**Development Permit Panel
Wednesday, August 24, 2016**

1. Development Permit 10-521415
(REDMS No. 4707564)

2. Development Variance 15-718208
(REDMS No. 5089208)

3. Development Variance 16-732402
(REDMS No. 5059809)

Landscape Plan
1/8" = 1'-0"

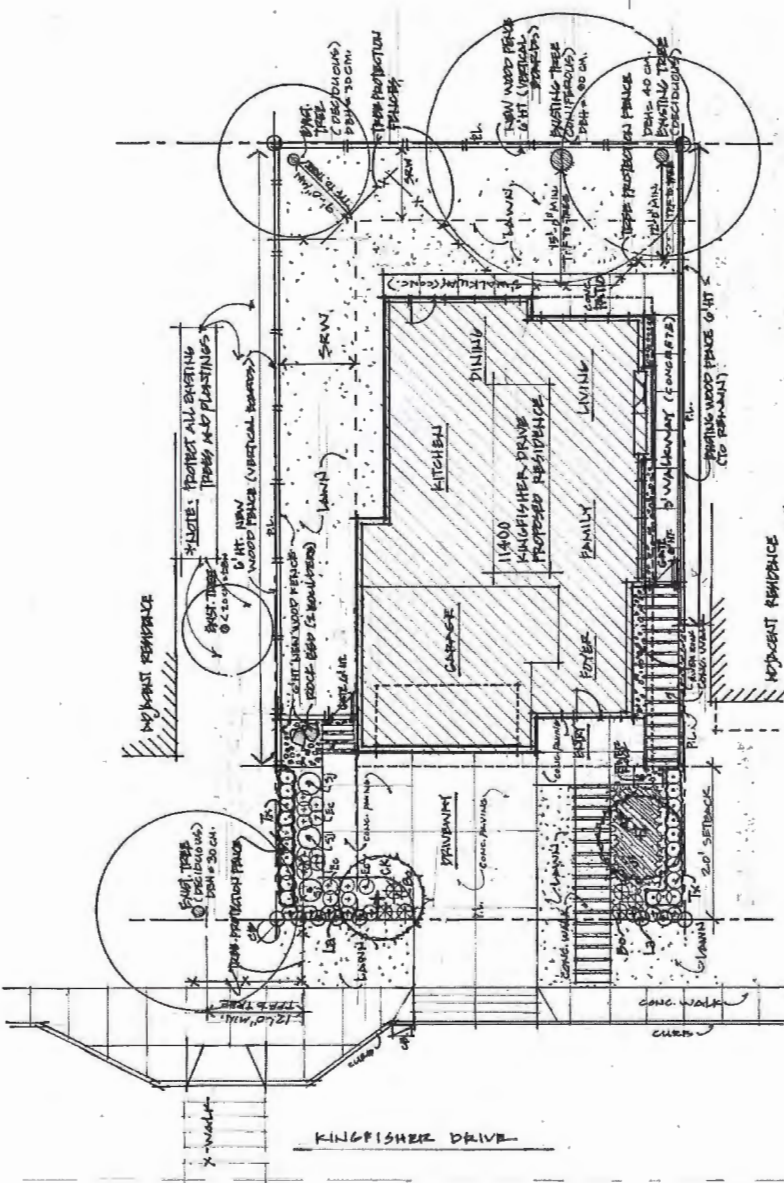
The one aspect of the new construction that I have some lingering concerns about is the removal of the existing Cedar hedge on the north side of 11400 Kingfisher drive (shared as a boundary between my home and the proposed new home). The applicants have proposed to replace the tall cedar hedge with Hicks Yew and let it grow to four feet as four feet is the permitted height of the barrier (fence or hedge) between properties in the front yard . I just want to bring to the notice of the variance panel members that the existing cedar hedge runs 39/40 feet along the boundaries of our homes and hence it runs much deeper than the front yard setback which is 20 feet on our lots.

I am requesting that the last six feet of the existing Cedar hedge (upto my red garden gate from the back of the property), be replaced by a fence panel instead of being re-planted with Hicks Yew (the proposed hedge plant in the applicants' landscaping plan). Currently the last six feet or so of the existing cedar hedge functions as the main barrier between our properties and is part of my side yard/ garden . **Please see the attached picture for details.**

In response to ██████████ correspondence, Mr. Craig advised that (i) the applicant has confirmed in writing that the replacement fencing along the north property line will extend up to garden gate of ██████████, (ii) the applicant has expressed willingness to discuss with ██████████ regarding the timing of the installation of the replacement fencing at the north property line, and (iii) the proposed 4 feet high Hicks Yew hedging is consistent with the City's regulations on maximum fence height within the front yard.
